Final Decision

Planning Commission

File number(s): DR 23-09, SA 23-07, & VAR 23-07
Project name: Salud Medical Center Renovation
Date of decision: January 11, 2024
Date of mailing: January 19, 2024
Applicant: Meghan Panarella, Clark Kjos Architects
Landowner: Yakima Valley Farm Workers Clinic
Site location: 1175 Mt Hood Avenue (Tax Lot 051W08BC00800)
Decision: Approved with Conditions

Site Plan

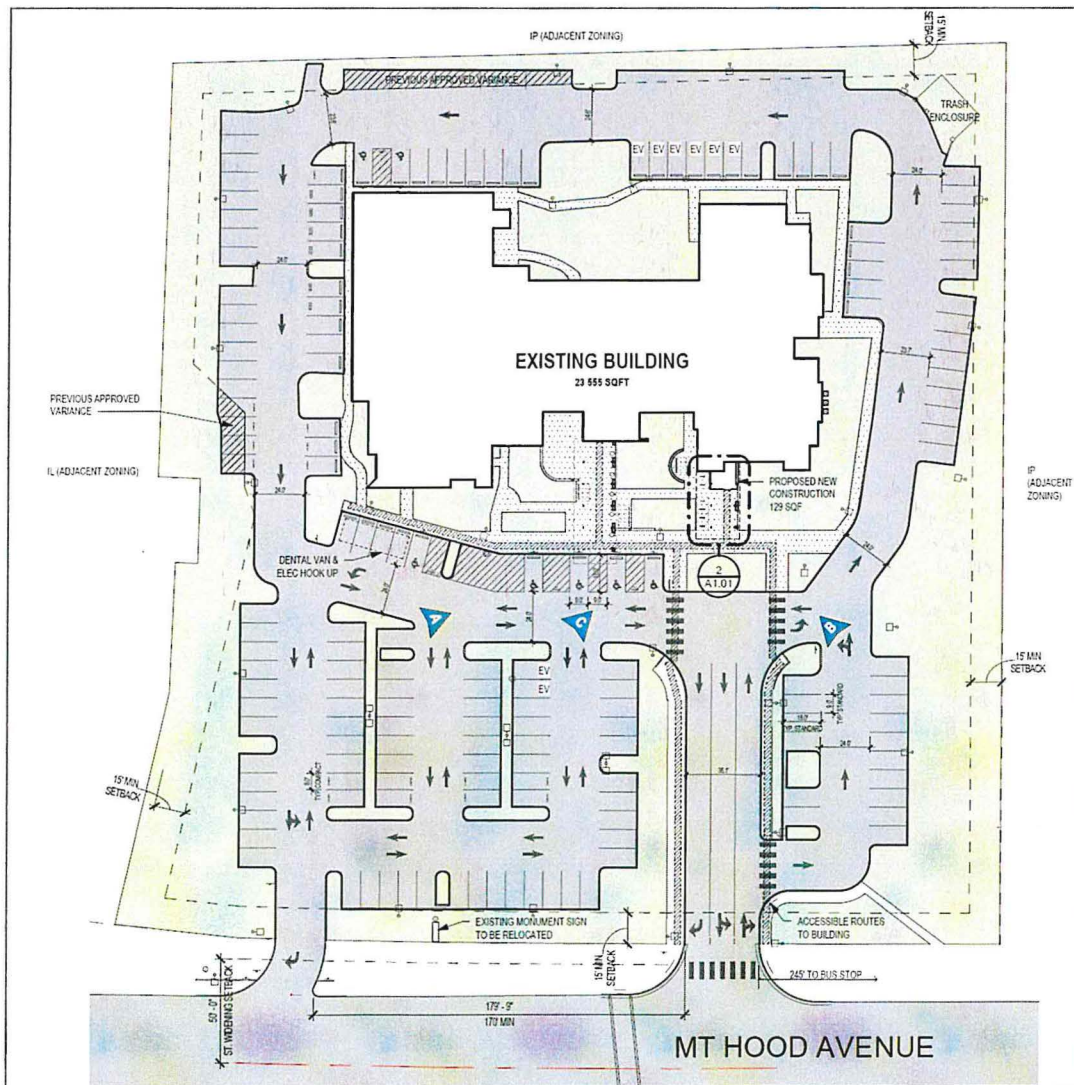
1. Substantial conformance: The applicant or successor shall develop the property in substantial conformance with the final plans submitted and approved with this application, except as modified by these conditions of approval. Were the applicant to revise plans other than to meet conditions of approval or meet building code, even if Planning Division staff does not notice and signs off on building permit issuance, Division staff retains the right to obtain restoration of improvements as shown on an earlier land use review plan set in service of substantial conformance.

9. Underground utilities: Pursuant to 3.02.04, all utility services to and within the development shall be underground.
10. Second driveway: The following conditions apply to the proposed second driveway:

- a. Pursuant to 3.04.01D, the developer shall obtain the necessary approvals and/or permits from the Oregon Department of Transportation for the construction of a second driveway prior to building permit issuance. Documentation of the approval shall be provided as part of the building permit application.

- b. Pursuant to 3.04.03B3, the proposed second driveway shall function as a right-out-only driveway. The developer shall install traffic control signage and pavement striping around the driveway to appropriately communicate this to drivers. Details of signage and striping shall be provided as part of the building permit application.

- c. The maximum width of this driveway shall not exceed 12 feet at the property line.
11. On-site crosswalks: To meet 3.04.06D, the wide walkway crossings over the drive aisle shall be made visually distinct from the asphalt pavement by either using stamped concrete or constructing a raised walkway crossing. Revise site plans to demonstrate conformance as part of the building permit application.

12. Parking: The developer shall revise plans as needed to provide the following:
 - a. All existing and proposed parking stalls shall be delineated with double parallel line striping to meet 3.05.02K and Figure 3.05C.

13. Trash enclosure: To meet 3.06.05A and Table 3.06D, the existing trash enclosure must be enclosed within an architectural wall that meets the design standards outlined in 3.06.06B. Revise plans as needed to demonstrate conformance.

15. Signage: As indicated on the site plans, the developer shall relocate the existing monument sign prior to building permit final inspection. The developer shall apply for and obtain a Sign Permit for this relocated sign, along with any other new or modified signage. The sign variance approved in March 2020 (VAR 2019-10) for this property shall continue to apply.
